**Re: Route 66 Veterinary E.R. & Critical Care Center  
3601 Central Ave NE  
30-Day Temporary Certificate of Occupancy  
Transportation Development Final Inspection**  
Engineer's/Architect's Stamp dated 3-19-21 (K17D064)  
Certification dated 10-15-21

Traffic Circulation Layout

Re: **Permanent Certificate of Occupancy for  
Route 66 Veterinary Emergency & Critical Care Center  
3601 Central Ave NE  
Albuquerque, NM 87108**

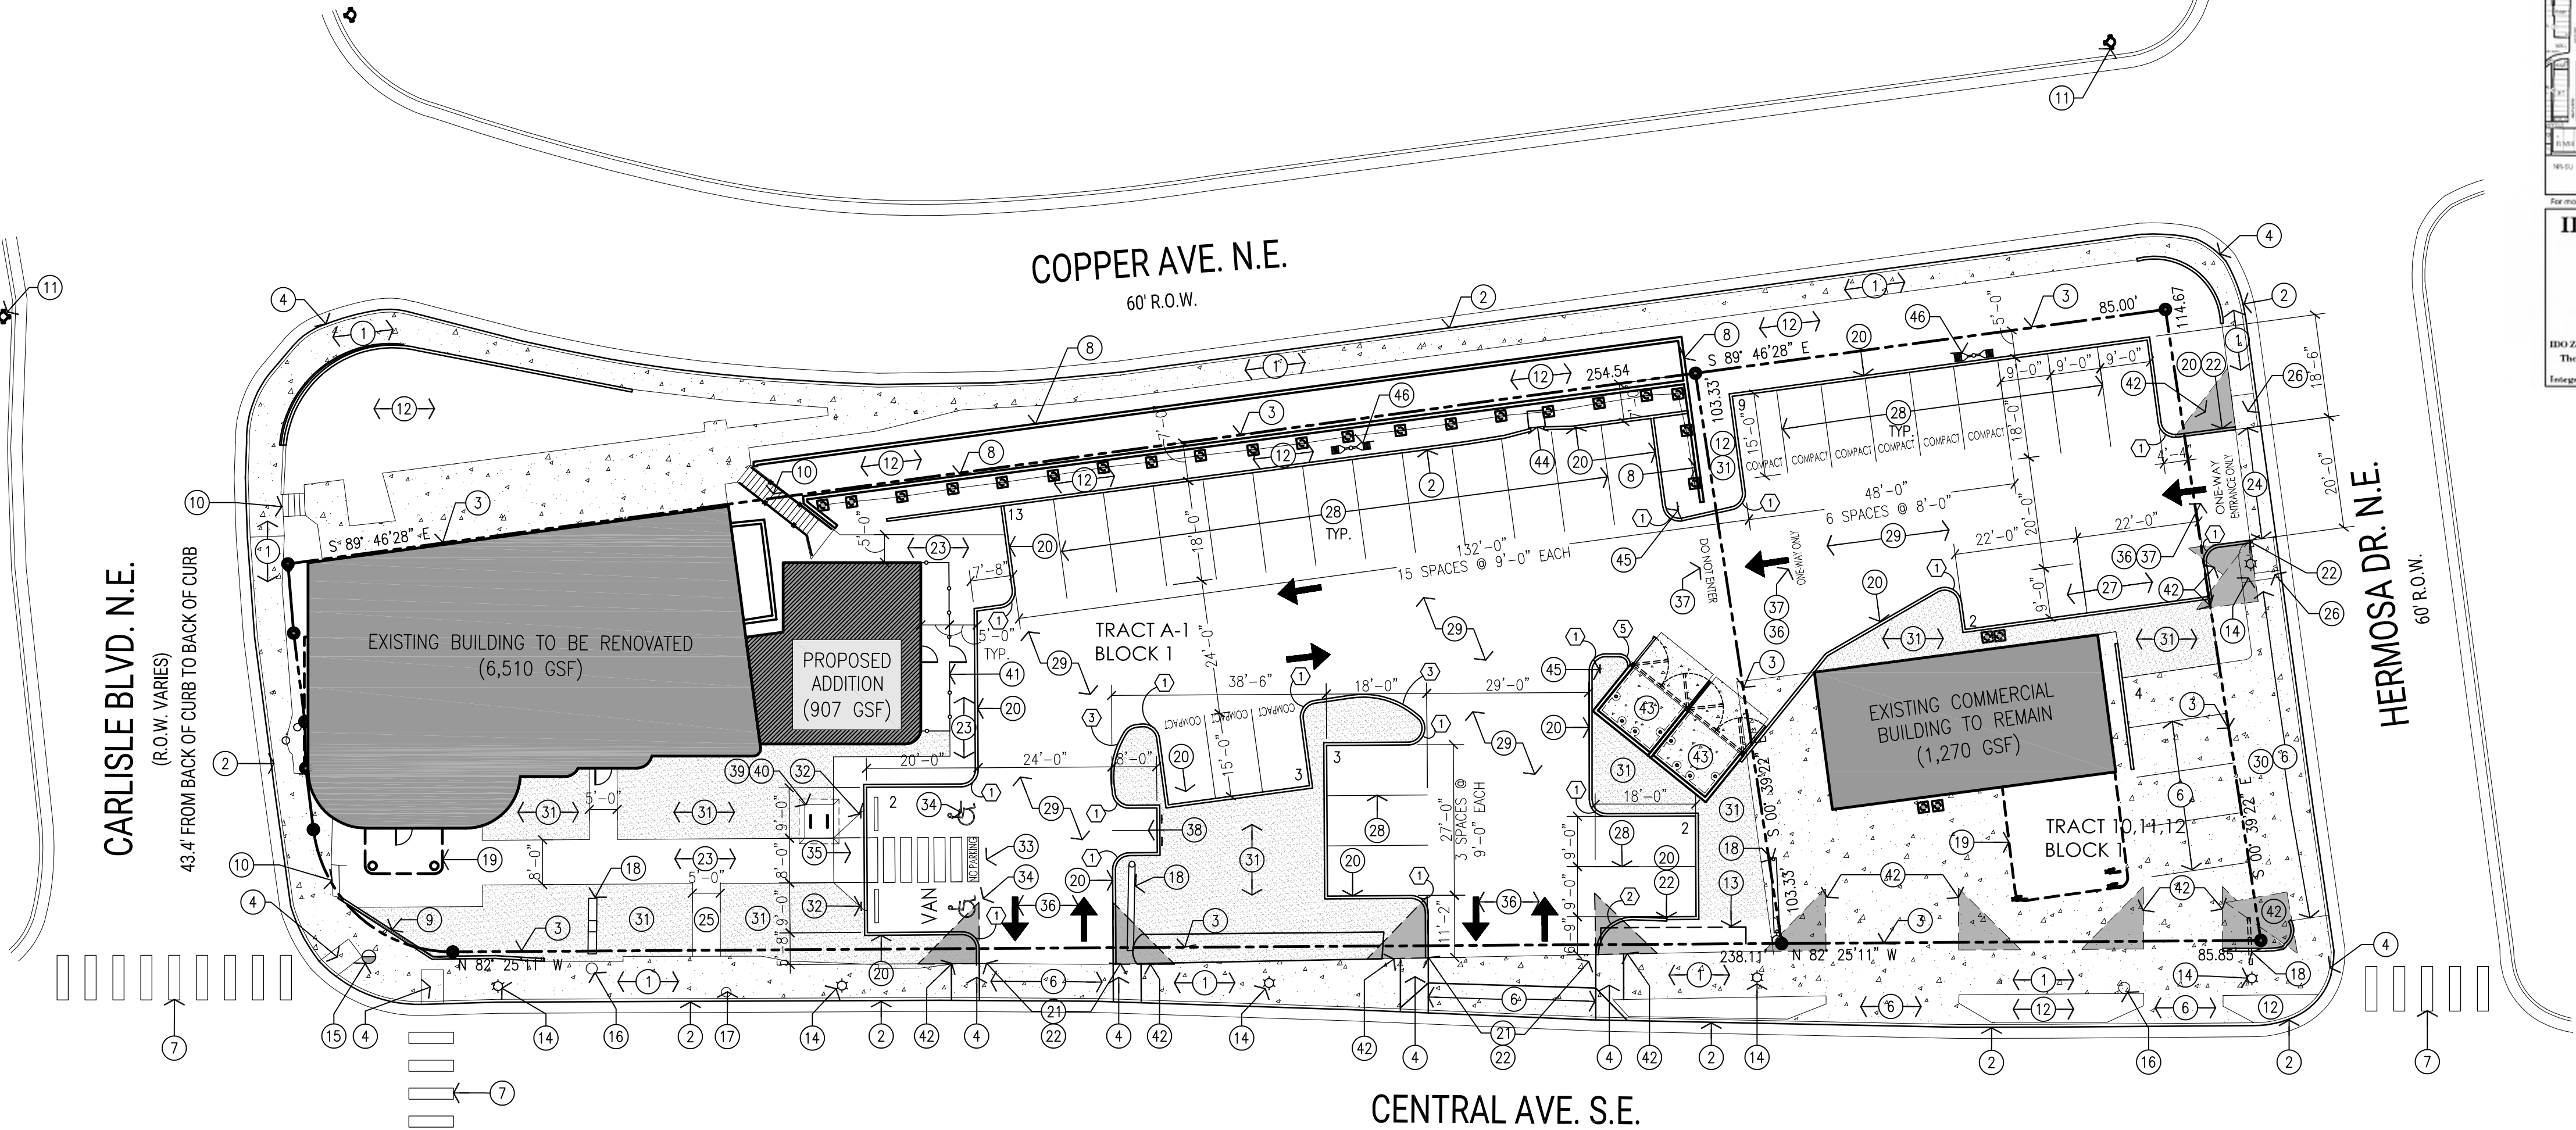
- Please complete items listed on Certification letter.
- Complete sidewalk patch off Copper.
- Complete landscaping, remove barricades, remove construction equipment and debris from site.

- Signage for the two accessible parking spaces (keyed note 32) have not been installed yet but will before final Certificate of Occupancy.
- Signage for the two motorcycle parking spaces (keyed note 38) have not been installed yet but will before final Certificate of Occupancy.
- 'Do Not Enter' signage at the one-way drive (keyed note 45) have not been installed yet but will before final Certificate of Occupancy.
- One space in the northeast row of 9 parking spaces was omitted to accommodate an existing mature tree. This row of 8 parking spaces are all now standard-size in lieu of the 'compact' spaces as approved. The reduction in parking spaces does not affect the required parking as the site plan has an excess of parking. The 'Parking Provided' calculations have been adjusted accordingly.
